Hurricane Planning Commission Meeting Agenda

December 8, 2022
5:00 PM

Agenda Date:	12/08/2022
Application Number:	2022-PP-24
Type of Application:	Preliminary Plat Application
Action Type:	Administrative
Applicant:	Western Mortgage and Realty Co
Agent:	Brent Moser
Request:	Approval of a Preliminary Plat
Location:	South of Sand Hollow Road and West of 3700 W
Zoning:	Recreation Resort and RM-3
General Plan Map:	Planned Community

Agenda Date:	12/08/2022
Application Number:	2022-ZC-38 2022-PSP-47
Type of Application:	Zone Change and Preliminary Site Plan Application
Action Type:	Legislative
Applicant:	Shadow Glen 420 Inc
Agent:	Frank Lindhart
Request:	A Zone Change from RM-2 and HC to RM-3 and HC with a PDO
Location:	100 N 2600 W
Zoning:	RM-2 and HC
General Plan Map:	General Commercial and Multifamily

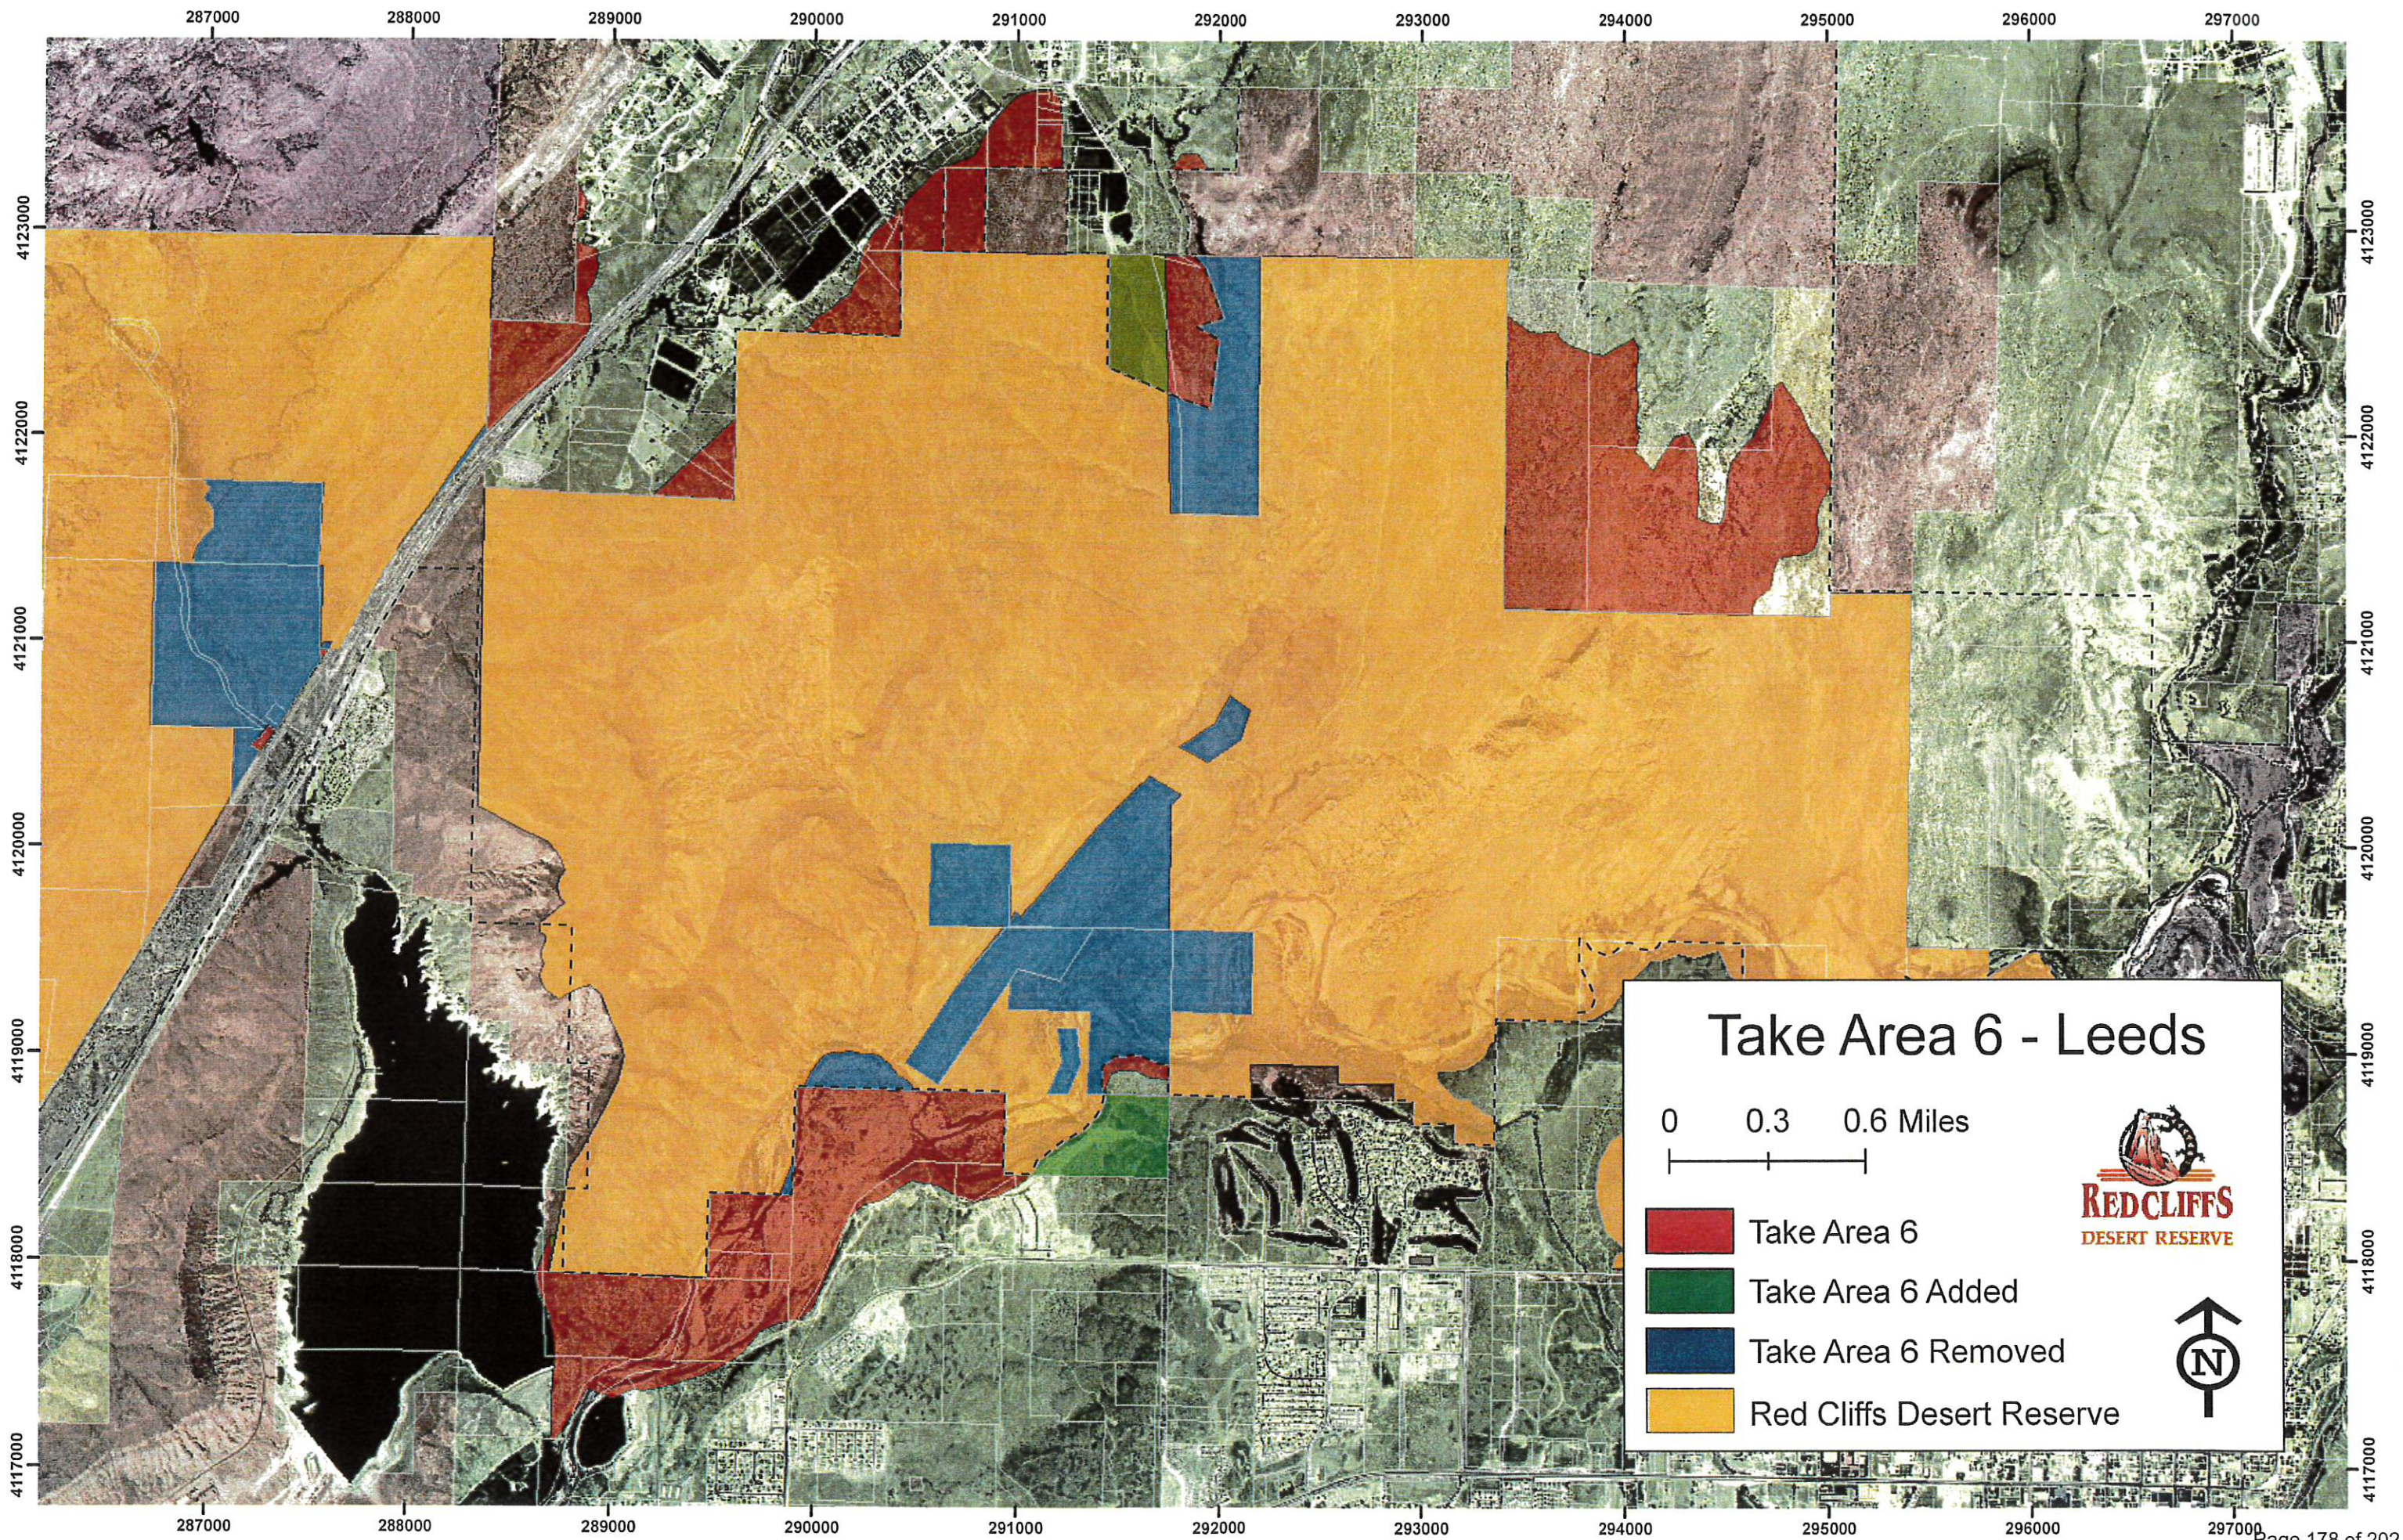
1. Private roadway should be public
2. Waterline easement should be in the public roadway
3. Plat indicates that the property is not in a desert tortoise take area
4. Possible creation of a landlocked lot on the south end of the property

This lot shares ownership with the lot to the northwest and will most likely be developed concurrently. So this is not a major concern for staff.
